2018 3.0 - Integral Abutment Directive Revisions

The Authority has received revised guidance from NJDOT regarding the coding of structures with integral abutments, which supersedes prior directions within notification No. 2017-2.0. The following example is provided to offer guidelines on how to report on Elements, SI&A coding and use of the new report forms related to Integral Abutments. Note bridges were previously coded using different directives and will require corrections based on the below.

Sample Bridge 1: Integral Abutment 50.43NO –
Turnpike SNO over Mill Lane and Pennsylvania Railroad "Kinkora Branch" (Abandoned)

TYPICAL SLEEPER SLAB PLAN
⅛" = 1'-0"

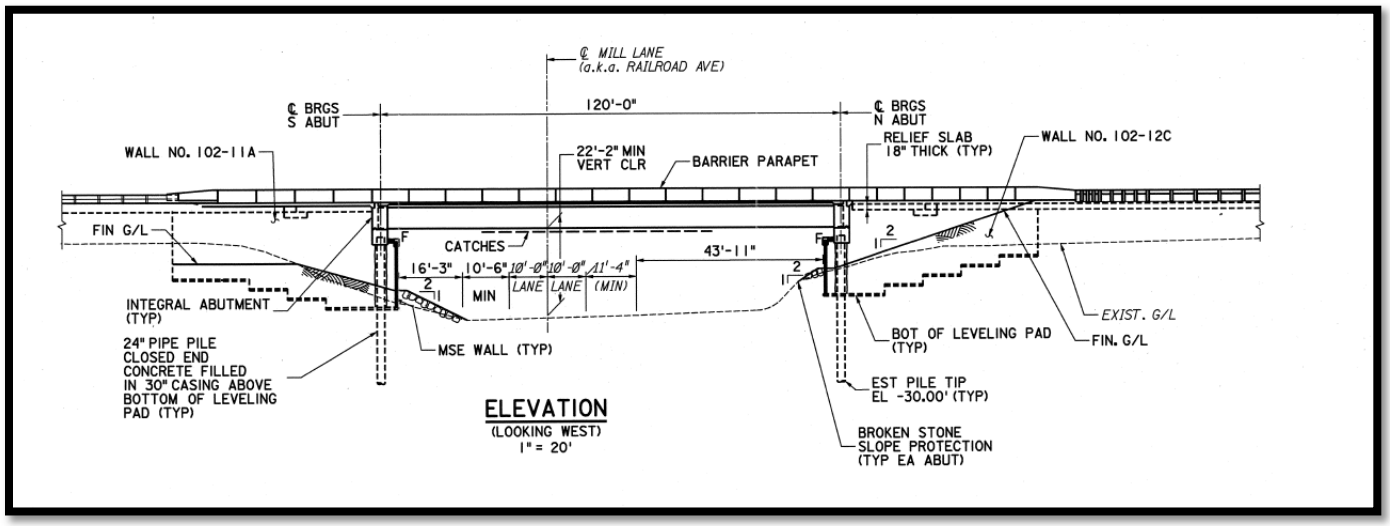
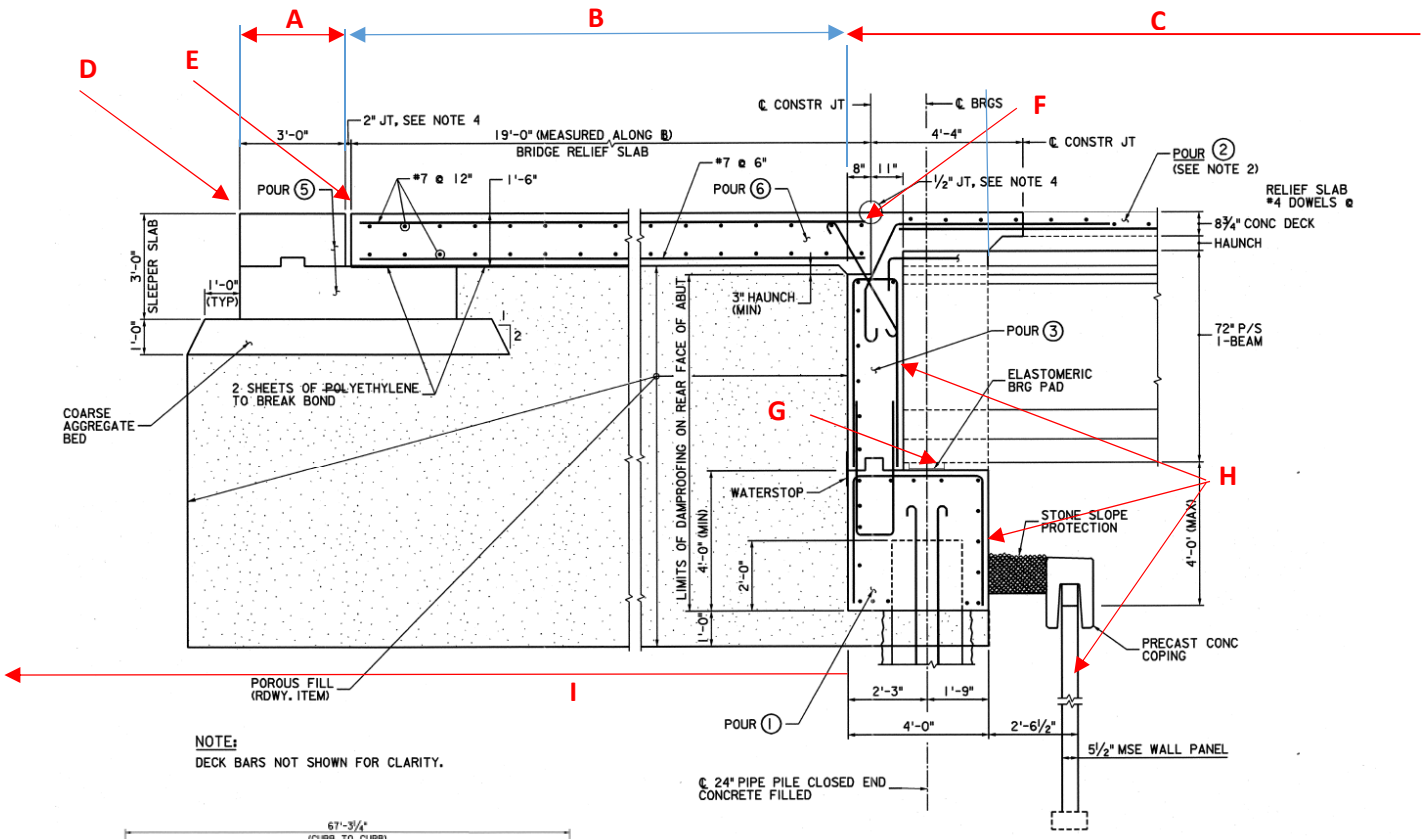
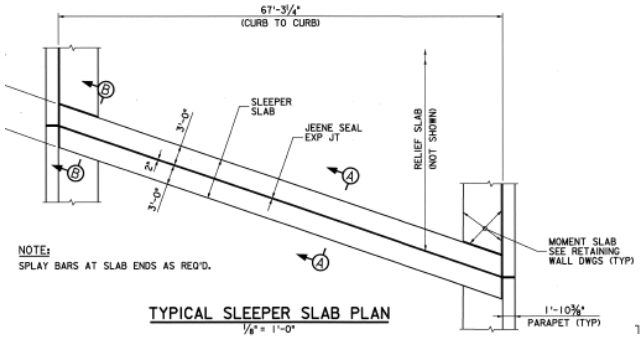
The example displays NJTA Report, Element and NBI coding guidelines for Integral Abutments. See notes* for specific requirements pertaining to Suspended Backwall designs.

Description	Field Forms	Elements	NBI
A	Visible portion of the top of the sleeper slab – 3' wide, disregard portion under relief slab.	Code defects related to the visible portion of the sleeper slab in the Approach Roadway 1 form.	**NOTE: DO NOT CODE IN NBE**	Item BA - Approach Roadway Condition For settlement of pavement adjacent to the edge of the slab or significant spalls in the slab
B	Relief slab	Code defects related to the relief slab in the Approach Roadway 1 form.

#321 – Reinforced Concrete Approach Slab (SF) #520 – Concrete Reinforcing Steel Protective System (SF)	Item BA - Approach Roadway Condition For significant spalls in the slab
C	Deck	Length of the deck shall be calculated back to back of backwall and will no longer encompasses the length of the deck and the relief slab. This length shall be applied to all longitudinal elements such as bridge rail (median and parapet barrier), sidewalk/curb, noise barrier, etc., as well as deck area. Code defects related to the deck on the Deck 3 (Top of Deck) Form

DO NOT Include relief slab deficiencies in this section.	#12 – Reinforced Concrete Deck (SF) #331 – Reinforced Concrete Bridge Railing (122 LF x 2) #520 – Concrete Reinforcing Steel Protective System (SF) *Note include all related deck items as/if necessary for each structure the above list is particular to this example (50.43NO)	Item 49 (Structure Length) – 122 LF (rear face of backwall to backwall) Item 48 (Length Max Span) – 120 LF (centerline bearing to centerline bearing) Deck Area –Structure Length x Out to Out width

JEENE SEAL EXPANSION
JOINT DETAIL
NTS

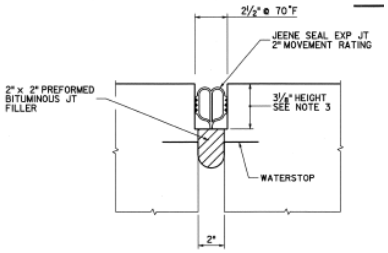
Description	Field Forms	Elements	NBI
D	Hot pour joint along back of sleeper slab at pavement interface	Code defects related to this hot pour joint in the Approach Roadway 1 form.	**NOTE: DO NOT CODE IN NBE**	N/A
E	Sealed joint between the sleeper slab and the relief slab shall be the Expansion Joint.	Code defects related to this expansion joint in the Deck 2 (Joints) form. Separate out each location with their own row and delineate as Expansion joint.

#302 – Compression Joint Seal (LF) Jeene Joint sealers are considered compression sealers and should be coded as such	N/A
F	Relief joint (construction joint) over the abutment	Code defects related to this expansion joint in the Deck 2 (Joints) form. Separate out each location with their own row and delineate as Construction joint.

RETAINING WALL NO. 402-8 AND MSN ABUTMENT WALL NO. 8 PLAN

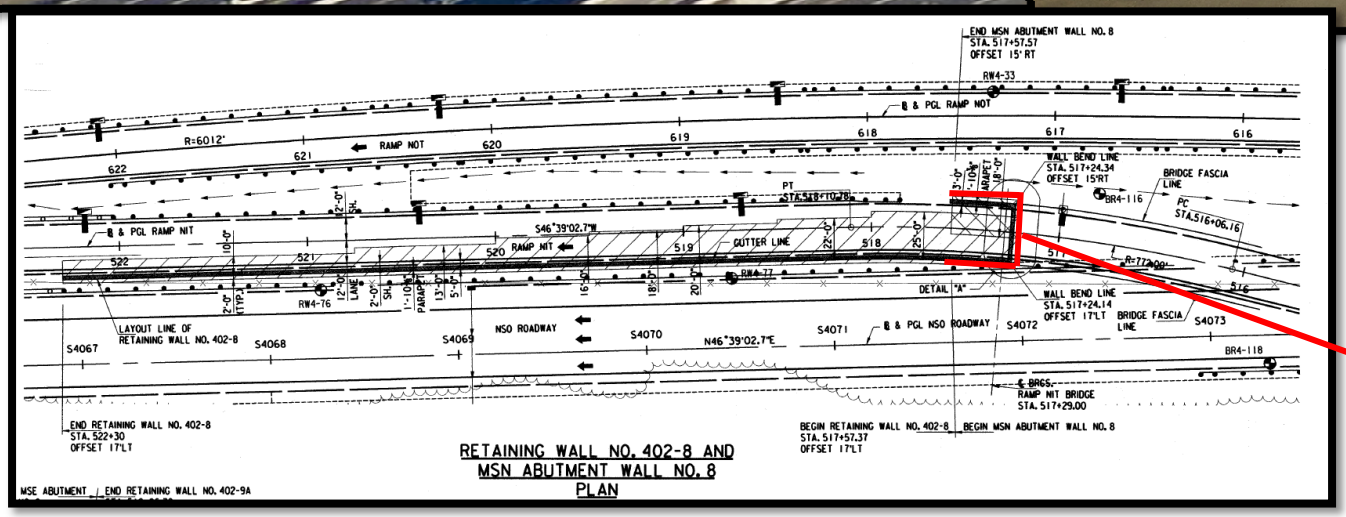
I: Use 25' per side.
